**Staff Report / Rapport du personnel**

**Subject / Objet :** subdivision with new street and variance

**File number / Numéro du fichier** 20-520 & 20-1525

**AMENDING SUBDIVISION PLAN**  
**WHITE BIRCH ESTATES**  
**PHASE 10 SUBDIVISION**

**Site Plan Showing  
Proposed Development**

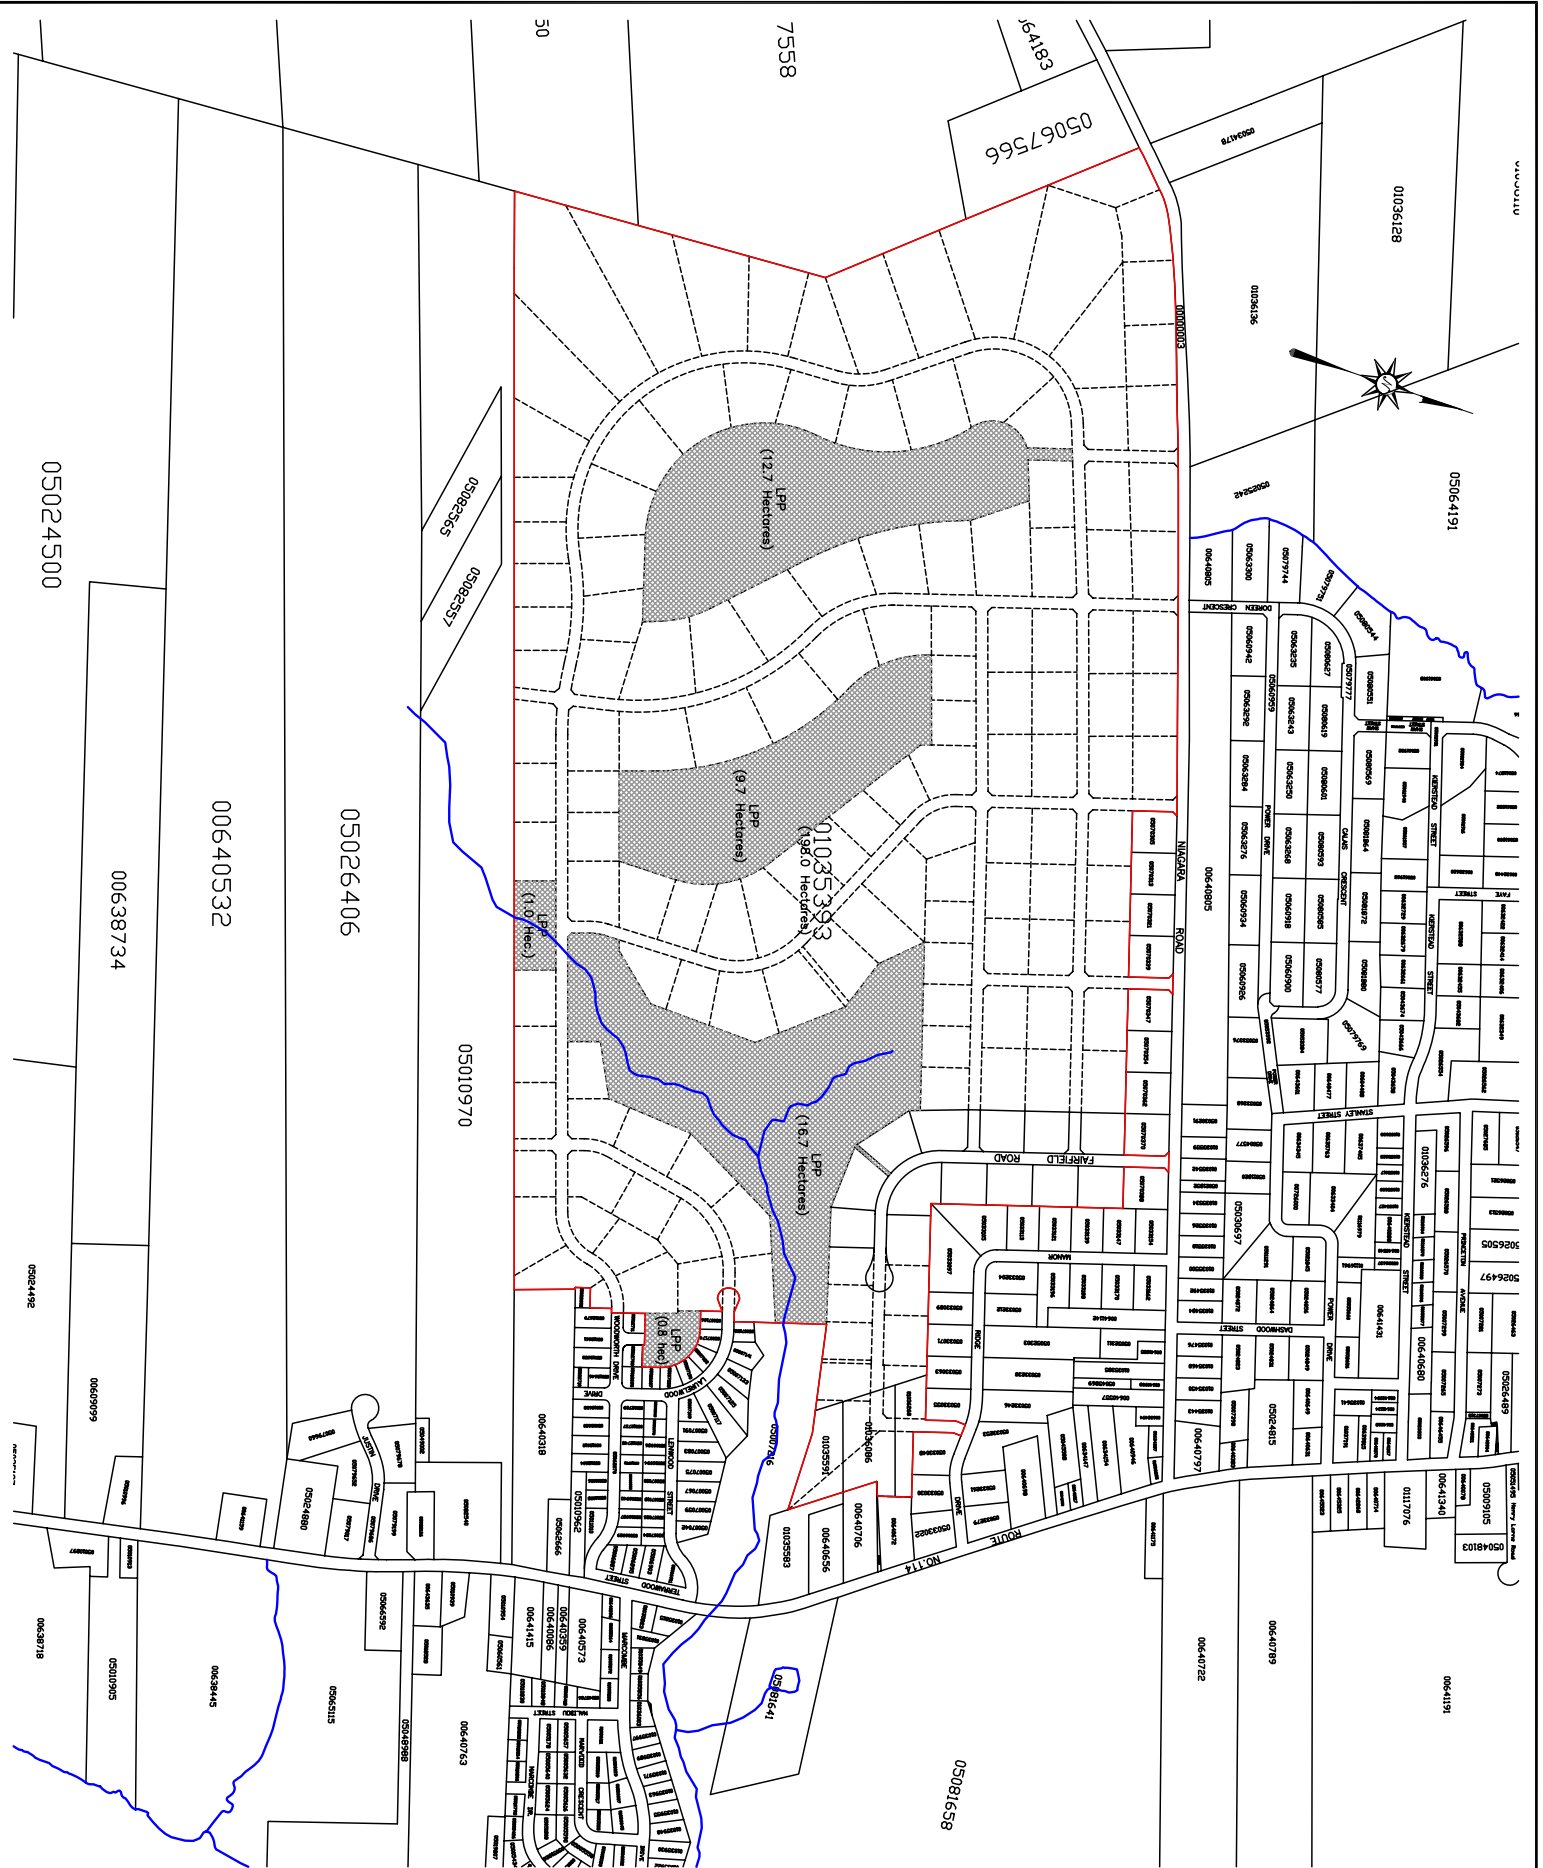
The length of the proposed cul-de-sac would exceed the 180m maximum length in the provincial subdivision regulation however this will be a temporary cul-de-sac and the Department of Transportation and Infrastructure has accepted the proposed layout. / *La longueur proposée du cul-de-sac dépasserait la longueur maximale de 180 m stipulée dans le règlement provincial sur le lotissement. Toutefois, ce cul-de-sac sera temporaire et le ministère des Transports et de l'Infrastructure a approuvé l'aménagement proposé.*

Staff respectfully recommends that the Southeast Planning Review & Adjustment Committee **approve** the variance request to exceed the permitted length of a cul-de-sac from 180m to 365m. / *Les membres du personnel recommandent respectueusement que le comité de révision de la planification du Sud-Est **approuve** la demande de variance pour augmenter la longueur permise d'un cul-de-sac de 180 m à 365 m.*

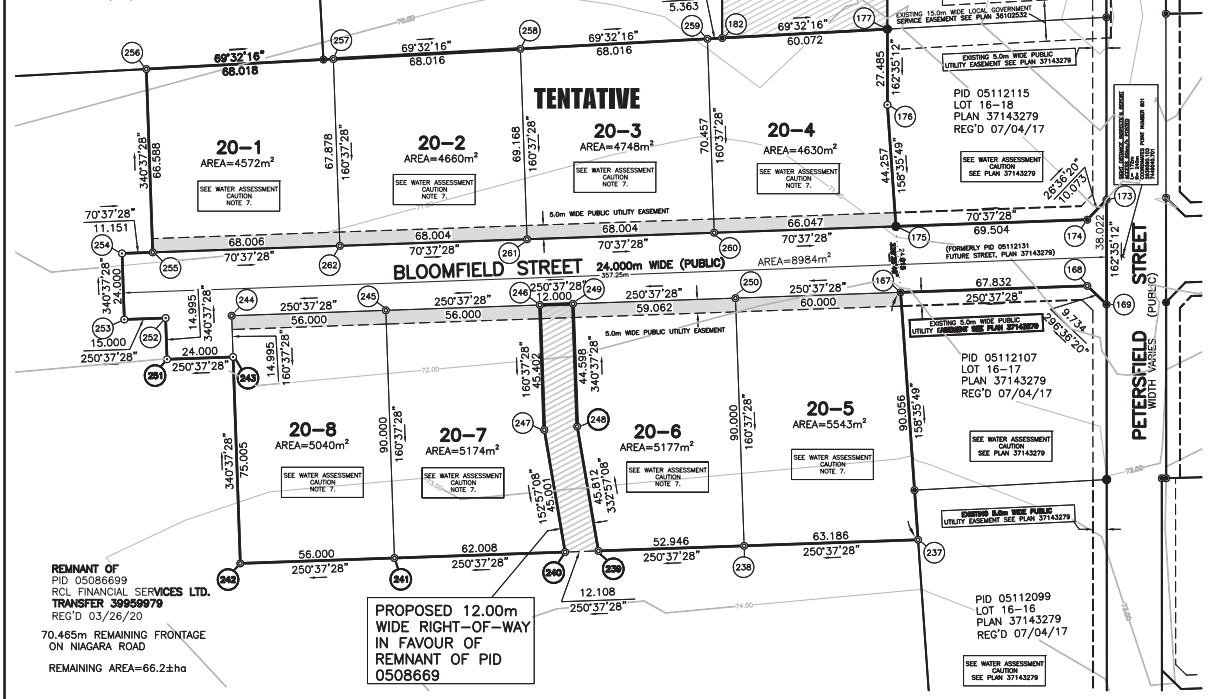
The location of the proposed street(s) shown on the tentative subdivision plan mentioned above is acceptable to the Department of Transportation and Infrastructure.

- The developer is required to submit a street design including a plan and profile and cross sections showing top and bottom of foreslopes and backslopes, direction of ditch flow, pipe sizes, Municipal Services Easements and street right-of-way width for the proposed streets. The design drawings must be prepared and stamped by a registered Professional Engineer of New Brunswick **and submitted to the Department prior to the Minister signing the final plan.**

- The drainage system shall be designed to consider the drainage basin as a whole and must accommodate not only runoff water from the subdivision area but also, where applicable, the system shall be designed to accommodate the runoff water from those areas adjacent to and upstream from the subdivision itself, as well as its effects on lands downstream. It is the developer's responsibility to determine how the run-off water from the lots and the proposed public streets will be carried away to ensure that it does not have a negative effect on the proposed lots and the existing properties in the area. **A detailed drainage report must accompany the drainage plan in order to evaluate the drainage pattern. Where environmental permits are required, copies should be forwarded to the Department of Transportation and Infrastructure. Prior to the Minister signing the final plan, stamped copies of the engineered drainage study and design shall be forwarded to the Department.**

- The right-of-way limits at the proposed street intersection(s) shall be laid out as shown on "**Figure A10**" of the Minimum Standards.
- Any temporary turnaround must meet the requirements shown in "**Figures A3, A4 or A5**" of the Minimum Standards.

- Additional street right-of-way allowance will be necessary where the topography of the land or the soil type requires extra width for deeper or wider ditches. The street right-of-way may have to be widened to more than the standard 24 metres in some areas to ensure that the ditch and the backslope/foreslope are within the area to be vested in the Crown as a public street. The additional street right-of-way width will be necessary for future street maintenance activities. Standard survey markers shall not be placed in the ditches.
